ITEM: 6.2	REPORT SUMMARY MINOR VARIANCE APPLICATION FILE NUMBER A004/25
------------------	--

MINOR VARIANCE APPLICATION FILE NUMBER A004/25

CITY WARD #:	3
APPLICANT:	Bradley and Vanessa Smith
AGENT:	Andrew Solari and Charlie & Alessandro Bancheri (Bancheri Bros)
PROPERTY:	110 Purple Creek Road, Woodbridge
ZONING DESIGNATION:	See below.
VAUGHAN OFFICIAL PLAN (2010) DESIGNATION:	Vaughan Official Plan 2010 ('VOP 2010'): "Low Density Residential" by Map 12.13 A - Land Use of Chapter 12.13, Volume 2 (Block 40/47 Area Specific Policy)
RELATED DEVELOPMENT APPLICATIONS:	N/A
PURPOSE OF APPLICATION:	Relief from the Zoning By-law is being requested to permit a proposed cabana and ground mounted pool equipment in the rear yard.

SCHEDULE A: DRAWINGS & PLANS

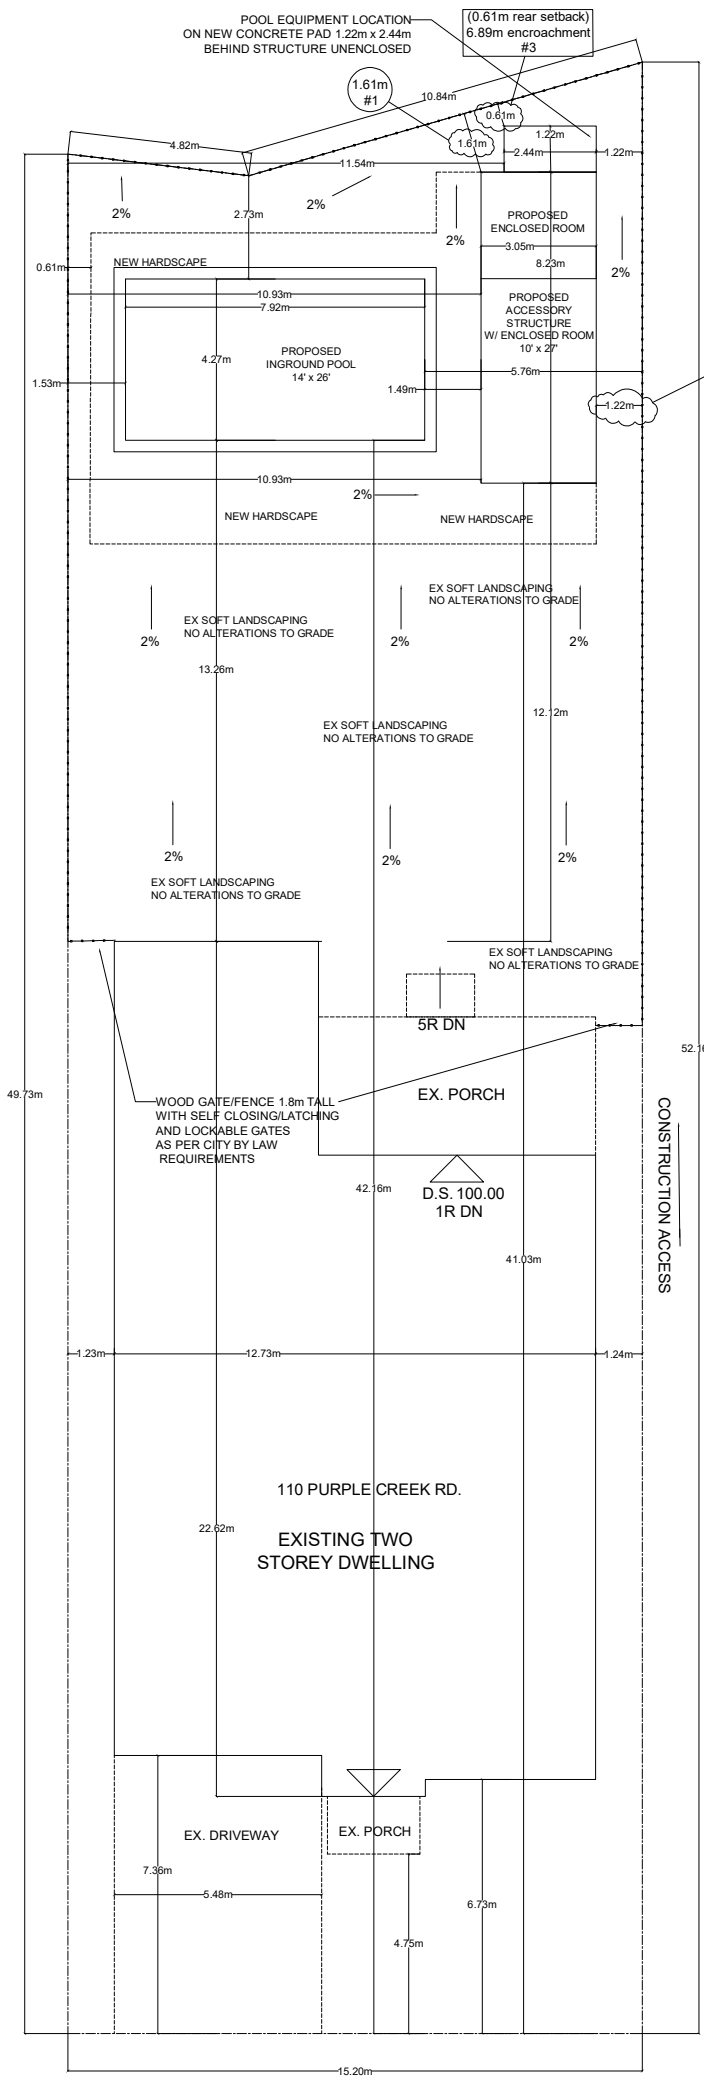
The Development and Parks Planning Department has no objections to Variance 1 and 2 to reduce the setbacks from the proposed cabana to the rear lot line and south interior lot line. The proposed setback reductions are sufficient for access and maintenance. The proposed cabana is compliant with maximum height and lot coverage provisions, and is not anticipated to incur any negative impacts on the neighbouring residential properties. Environmental Planning staff have reviewed the application and do not anticipate any negative impacts on the woodlot to the east.

The Development and Parks Planning Department has no objections to Variance 3 to increase the maximum permitted encroachment of the pool equipment pad from 1.5 m to 6.89 m. The proposed pool equipment pad is located between the cabana and the rear lot line. The proposed equipment pad maintains a 0.61 m setback from the rear lot line, which is sufficient for access and maintenance. The increased encroachment into the rear yard is not anticipated to create noise or massing impacts on the abutting properties.
